Fatal Crash Review

Location: Wightman Road & Aspenwood Lane

Local case number: 230020241 Date: 05-10-23

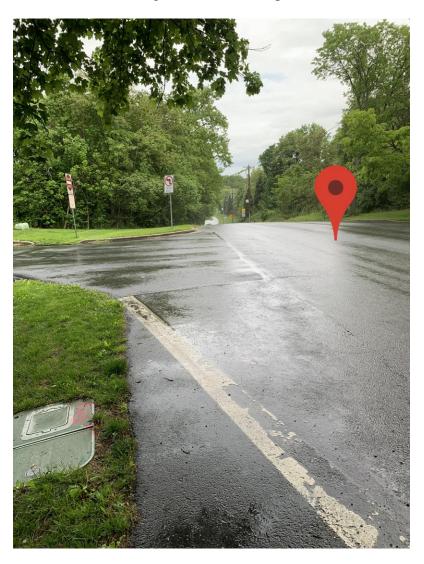
A field investigating was conducted at the crash site on May 09, 2023. Along the southbound Wightman Road approach to Aspenwood Lane there is a moderate upgrade to the slight oververtical at Aspenwood Lane. There are intersection advance warning signs posted along both Wightman Road approaches to Aspenwood Lane and there is sufficient sight distance in all direction at the intersection. Intersection lighting is provided on a utility pole at the NE corner of the intersection, the county streetlight map indicates it is operational. Several signs near the intersection are old, faded, and the knocked down Adopt-A-Road sign is covered up by mud.
